## Appendix IV

### NRC Staff Computational Fluid Dynamics Simulations in Support of the SONGS Audit

The San Onofre Nuclear Generating Station (SONGS) licensee performed computational fluid dynamics (CFD) simulations with the FLOW-3D code that were used as an input to its debris transport analysis [1]. The licensee considered two CFD cases, a large break on the Loop 1 hot leg (Case 1) and a large break on the Loop 2 hot leg (Case 2). The licensee provided FLOW-3D input decks for these two cases for the staff to review during the audit.

**Figure 9: Increased Computational Mesh Resolution Case  
Containment Pool Velocity 1 Inch Above Floor [ft/s]**

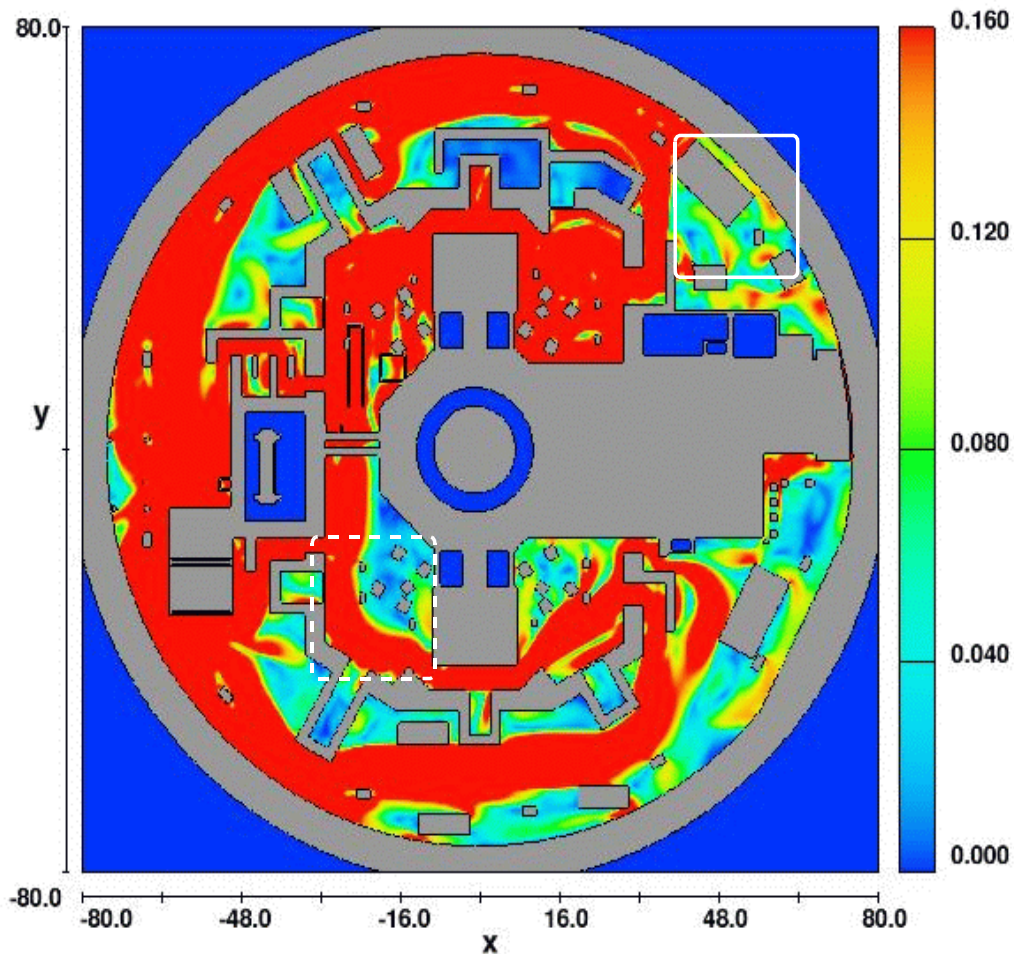
The overall flow pattern depicted in Figure 9 is similar to that shown for the baseline results in Figure 1. However, several noteworthy differences are apparent, the most significant of which is highlighted inside a dashed-line box located on the southwest side of the Loop 2 compartment. On Figure 9, the flow within the dashed-line box appears to be concentrated along smooth streamlines hugging the outer compartment wall. In contrast, the flow in this region on Figure 1 appears diffuse and is not well-developed, presumably having been disturbed by small obstacles in the loop compartment.

A second noteworthy difference can be observed in the upper northeast quadrant of the containment pool, within the solid-line box near the containment wall. The predicted flow between the large rectangular obstacle and the containment wall is significantly reduced in Figure 9 as compared to Figure 1. Other more subtle changes in the flow pattern can also be observed for the increased mesh resolution case, particularly in areas where obstacles are present.

The differences between Figures 1 and 9 can be primarily attributed to the difference in the resolution of their respective computational meshes. In particular, the increased resolution of the mesh used to generate Figure 9 likely permitted both the containment geometry and the pool flow characteristics to be represented more accurately. However, a secondary cause of the differences is the fact that Figure 9 is based on a 700-second simulation, whereas Figure 1 was based on a 300-second simulation. The increased simulation time likely allowed the flow pattern in Figure 9 to approach steady-state conditions more closely than the baseline case. Additional examination of extending the simulation time of CFD runs is provided below in the discussion of the following sensitivity case (Case 1-8).

**Figure 10: Increased Mesh Resolution Case  
Containment Pool Velocity 3 Inches Above Floor [ft/s]**

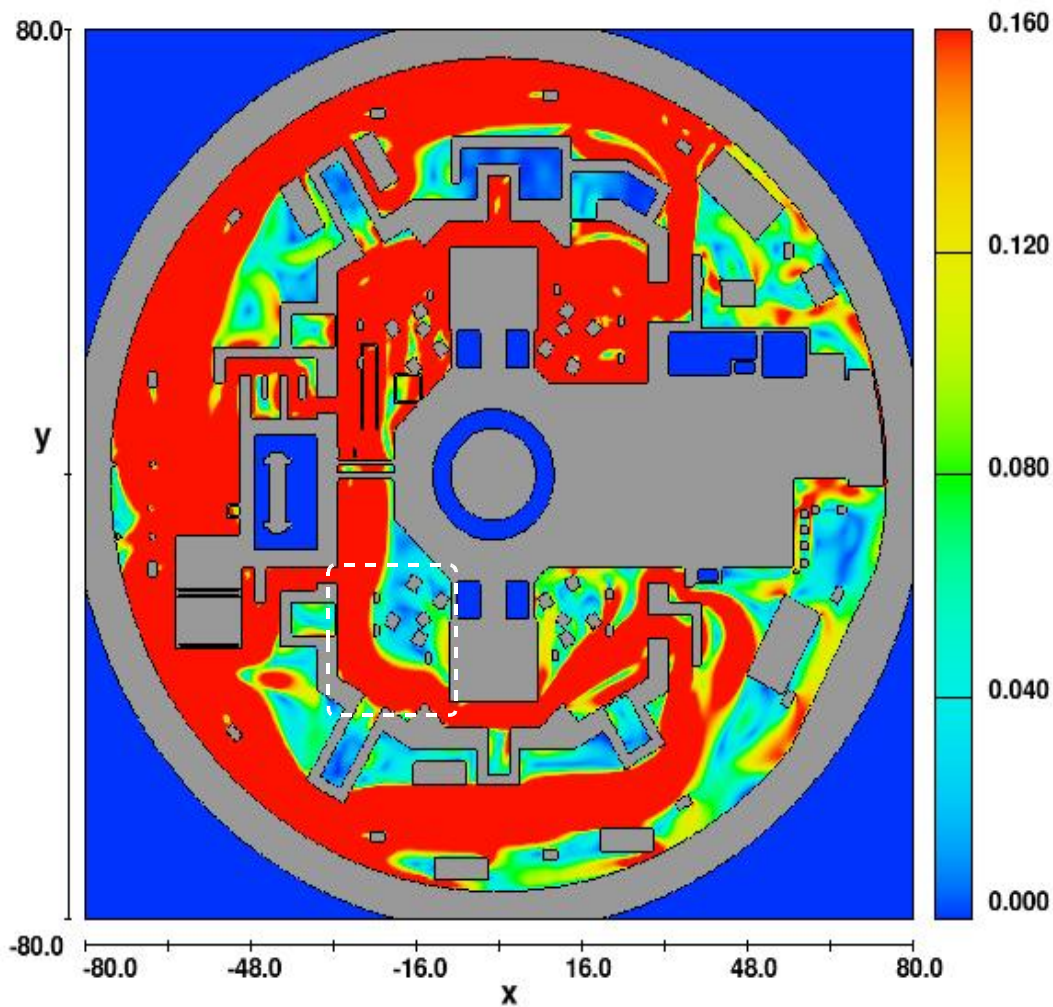
Although there are several minor differences between Figures 9 and 10, these are inconsequential with respect to debris transport. This observation indicates that the differences in containment pool flow observed in Figures 9 and 10 when compared to Figure 1 are likely the result of the refined mesh (and increased simulation time), not the difference in the pool depth at which they were generated.

Based upon the assumptions made by the licensee (particularly the assumed initial spatial distribution of debris and the assumed lack of debris settling in Loop 2), the changes in the predicted containment pool flow pattern attributed to the increased mesh resolution did not lead to the identification of non-conservatism in the SONGS analysis. However, the change in the predicted flow in the southwest part of the Loop 2 compartment (highlighted again in the dashed box on Figure 10) could be important for other plant containment geometries and post-accident conditions, which demonstrates the potential significance of mesh resolution on the predicted flow pattern.

**Figure 11: Extended Simulation Time Case  
Containment Pool Velocity [ft/s]**

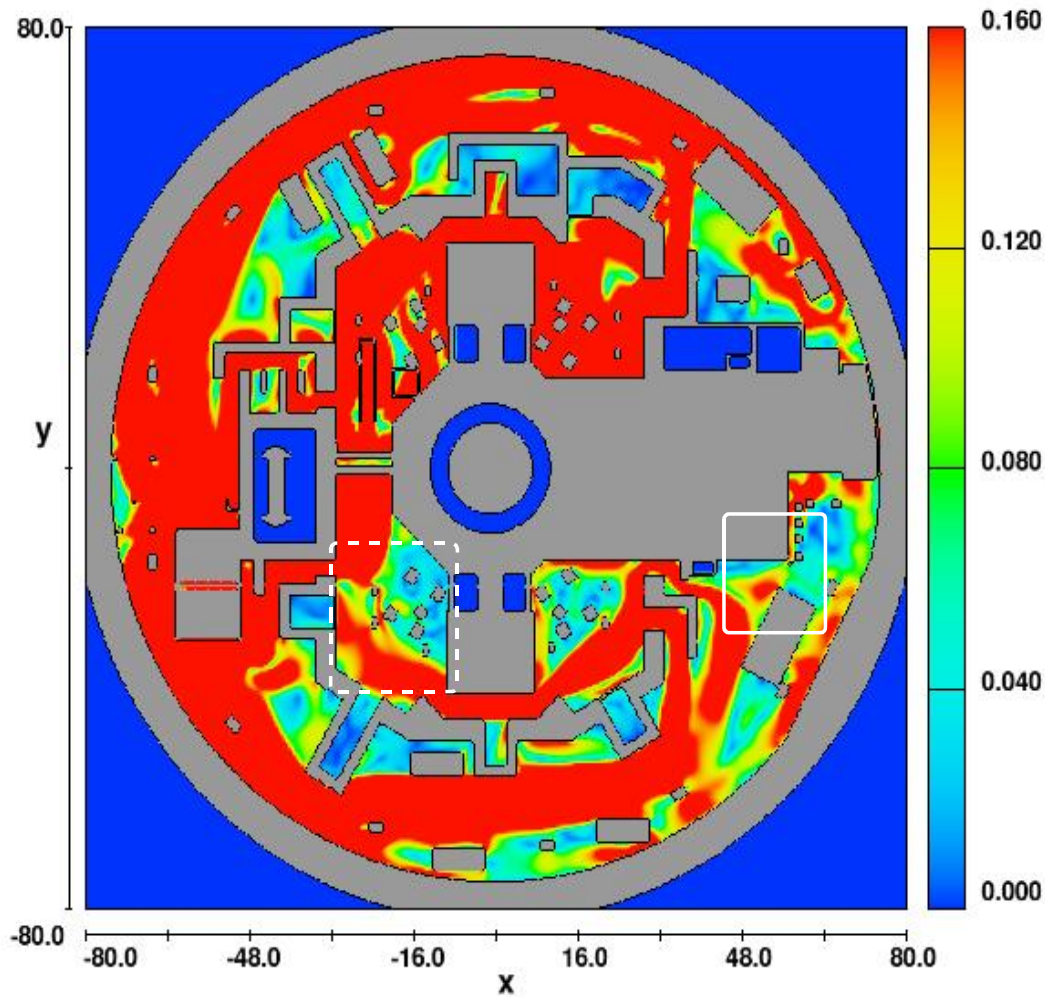
While, once again, the global flow pattern in containment is not significantly affected by the increased simulation time, several interesting changes to the flow field can be noted. Two of the most notable changes with respect to the debris transport analysis are highlighted on Figure 11. First, the dashed-line box on Figure 11 shows the velocity magnitude contours in the southwest corner of the Loop 2 compartment at a simulated time of 750 seconds. Figure 6 displays a velocity field of similar magnitude in this local region at 500 seconds. In contrast to these two plots, Figure 1 shows significantly lower velocities in this region at 300 seconds of simulated time. The comparison of these figures suggests that the velocity field in the southwest corner of the Loop 2 compartment has not been fully resolved at 300 seconds. This observation is further confirmed by sequentially examining several of the velocity magnitude contour plots for the three cases prior to 300 seconds (not shown in this appendix), which clearly indicate that the flow in this region is still rapidly developing. It is also noted that the area within the dashed-line box was previously examined on Figure 9, which presented the results of the increased mesh resolution case. By comparing Figures 9 and 11, the impact of the refined mesh can be appreciated in comparative isolation because the slight difference in run time for these two cases is not expected to have a significant impact on the simulation results.

The second noteworthy observation from Figure 11 is highlighted by the solid-line box in the southeast quadrant of the containment. This figure shows that, at 750 seconds of simulated time, the velocity field in the vicinity of the refueling canal drain line appears to be approaching the threshold at which some small pieces of mineral wool washed-down through the drain line could be transported to the recirculation sumps via tumbling. Note that the predicted flow field in Figure 11 for this region contrasts with that of Figure 1, which appears to indicate that small pieces of mineral wool washed down through the refueling canal drain would be highly unlikely to reach the recirculation sumps. Further consideration of Figure 6 indicates that, unlike the flow in the southwest corner of the Loop 2 compartment discussed above, the flow field in the region enclosed by the solid-line box has not completely developed, even at 500 seconds.

The two observations discussed above suggest that, while terminating CFD simulations based upon visual indications of mean kinetic energy versus time plots may be adequate for determining that a steady global containment pool flow pattern has been established, this criterion alone may not be generally adequate for concluding that predictions of localized flows with potential significance to the overall debris transport results have reached nearly steady-state conditions. (Recall that, as demonstrated by Figures 2 and 3, both the estimated mean kinetic energy and average turbulent kinetic energy had appeared relatively stable after a simulation time of 300 seconds for the baseline case.) As may be inferred from the observations cited above, local regions where the achievement of steady-state flow conditions may require additional time can often include areas where obstacles or constrictions are present, which tend to complicate predictions of the flow field. The staff found that using the FLOW-3D output files to examine of the progression of the CFD solution at various times prior to the simulation termination was useful in evaluating whether sufficient convergence had been achieved in local areas of potential importance to the debris transport results.

Despite this general concern with the licensee's methodology for terminating CFD simulations, the staff did not consider the SONGS debris transport results to be non-conservative because (1) debris settling was not credited in the southwest corner of the Loop 2 compartment where velocities were underpredicted in the baseline case and (2) staff sensitivity simulations, including Case 1-5 (Increased Containment Spray Flow Case), Case 1-6 (Increased Refueling

**Figure 12: Elimination of Containment Spray Alternating Horizontal Velocity Component Case, Containment Pool Velocity [ft/s]**

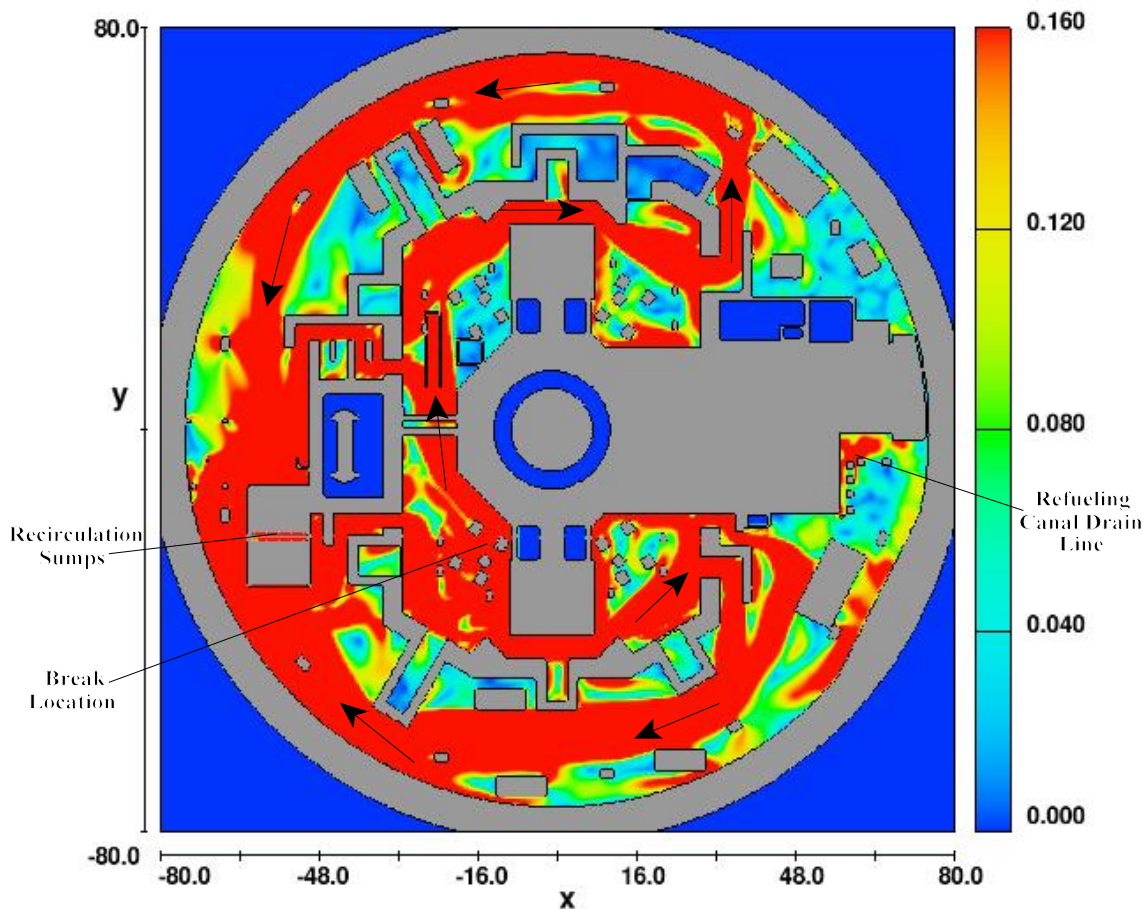
The staff noted that the containment pool velocity magnitude contours displayed on Figure 12 are very similar to those depicted in the corresponding figure in the licensee's debris transport calculation, Figure 5.9.29 [1]. Several minor differences were noted between the two figures, none of which appeared to have significant implications with respect to the debris transport results. Note also that slight differences are expected between Figure 12 and Figure 5.9.29 [1] as a result of the difference in the run times for the two cases and possibly the staff's input deck modification that removed the horizontal component of the containment spray vector.

Similar to the discussion for Case 1-4, the staff noted that the predicted flow field in the locations where containment spray is introduced to the model, particularly the regions near the containment wall on the west and south (i.e., left and bottom) of the containment pool, does not appear to be significantly affected by the removal of the alternating horizontal velocity component. As a result of this observation, the staff concluded that the presence of the alternating horizontal component of the spray vector did not appear to significantly influence the overall debris transport results for either the Case 1 or the Case 2 break.

**Figure 13: Southeast Passage Blockage Case  
Containment Pool Velocity [ft/s]**

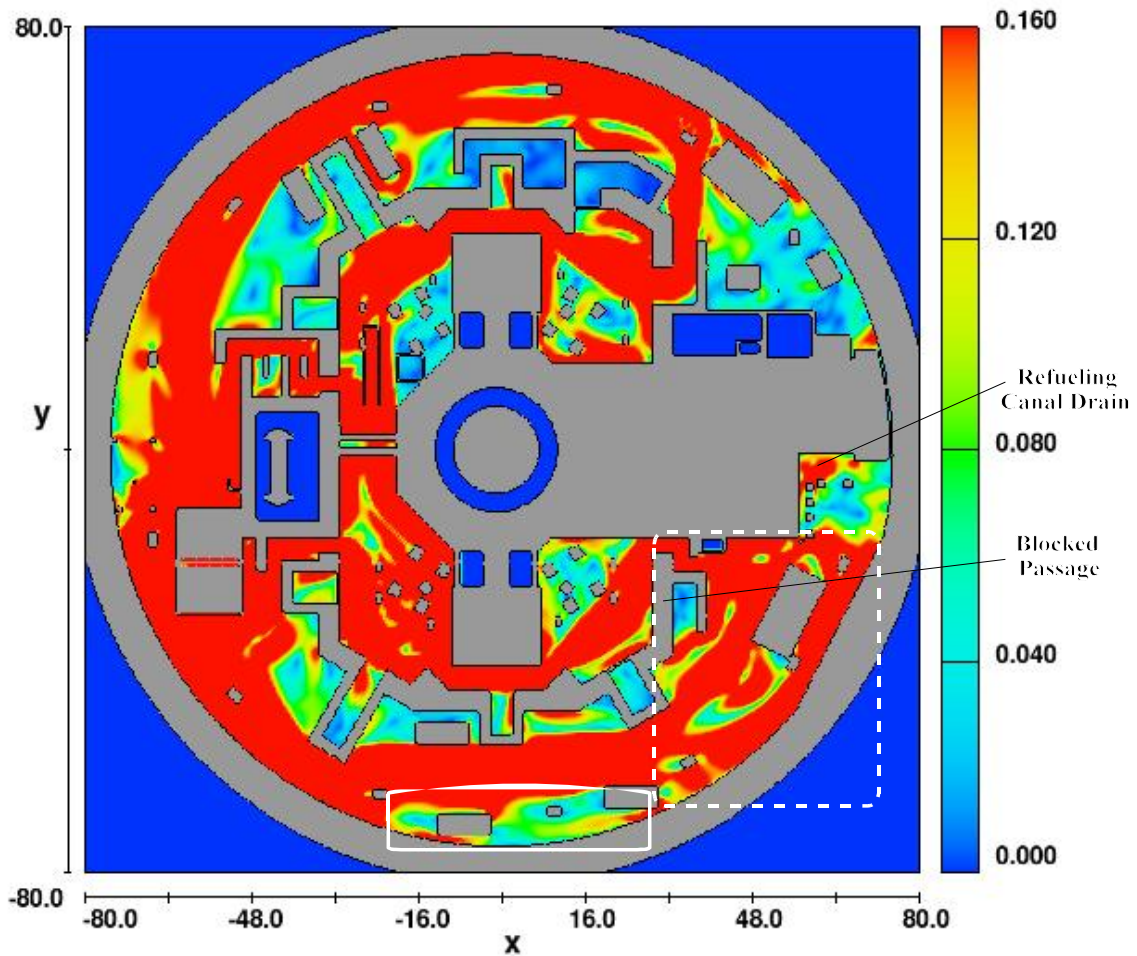
While the overall flow pattern in Figure 13 is similar to that of Figure 12 (which essentially serves as the baseline case for the Case 2 break), the flow velocities in a substantial portion of the southeast quadrant of the containment pool (highlighted in a dashed-line box on Figure 13)

appear to be increased by the explicit modeling of blockage at the lower southeast passage. Prior to running the simulation, the staff was concerned that these increased velocities could lead to additional transport of debris washed down through the refueling canal drain and along the south containment wall (highlighted in a solid-line box on Figure 13). However, Figure 13 indicates that local changes in the flow velocity do not significantly impact the refueling canal drain line area or the size of the low-velocity zone along the south containment wall.

Based upon the initial debris spatial distribution assumed by the licensee (refer to Section 3.5.3.1 of the main report), the flow velocity increases in the southeast quadrant do not significantly affect the overall debris transport results. However, the extent of the velocity increases shown in the southeast quadrant of Figure 13 could not have been fully appreciated prior to running the simulation. Therefore, while these perturbations were not ultimately significant for either the Case 1 or Case 2 SONGS input decks, their order of magnitude suggests that the area-based methodology used for computing debris transport fractions (this methodology is described in Section 3.5.4.2 in the main body of this report) could yield non-conservative results if applied in a similar manner to geometric and analytical conditions that may exist for other plants.

**Figure 14: Southeast Passage Blockage Plus Increased Refueling Canal Drainage Flow Case, Containment Pool Velocity [ft/s]**

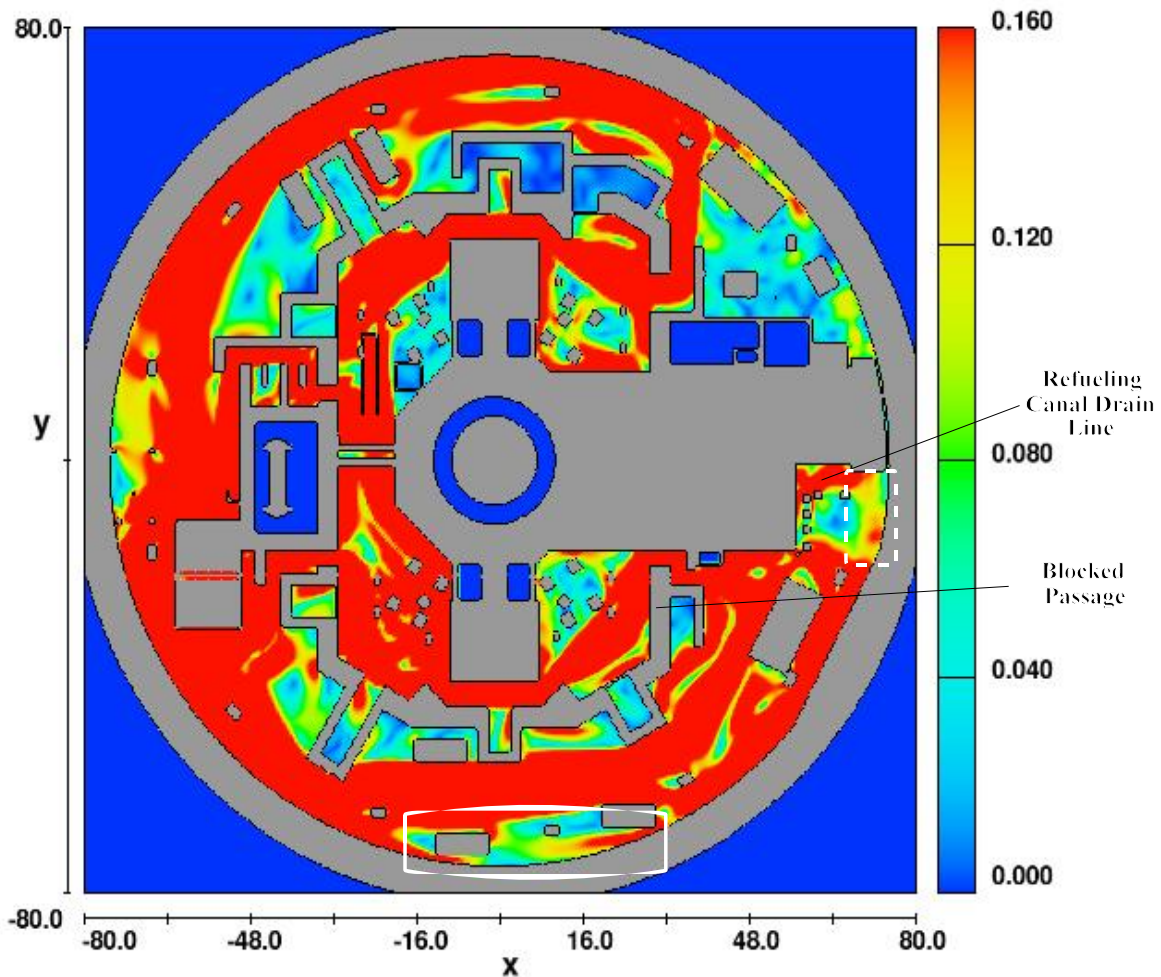
A comparison between Figures 13 and 14 reveals relatively minor differences when a 30% increase in the refueling canal drainage flow is explicitly considered. A dashed-line box on the east side of the containment near the refueling canal drain line shows one area where velocity increases are noticeable but not on the verge of continuously exceeding the 0.16-ft/s tumbling transport metric for small pieces of mineral wool. The solid-line box against the south wall of the containment shows that significant changes were similarly not predicted in the enclosed low-velocity region.

Based upon the results of this sensitivity simulation, the staff has confidence that small pieces of mineral wool washed down through the refueling canal drain line would not transport to the recirculation sumps and that the licensee’s transport analysis is relatively robust in the face of credible perturbations to the CFD model.
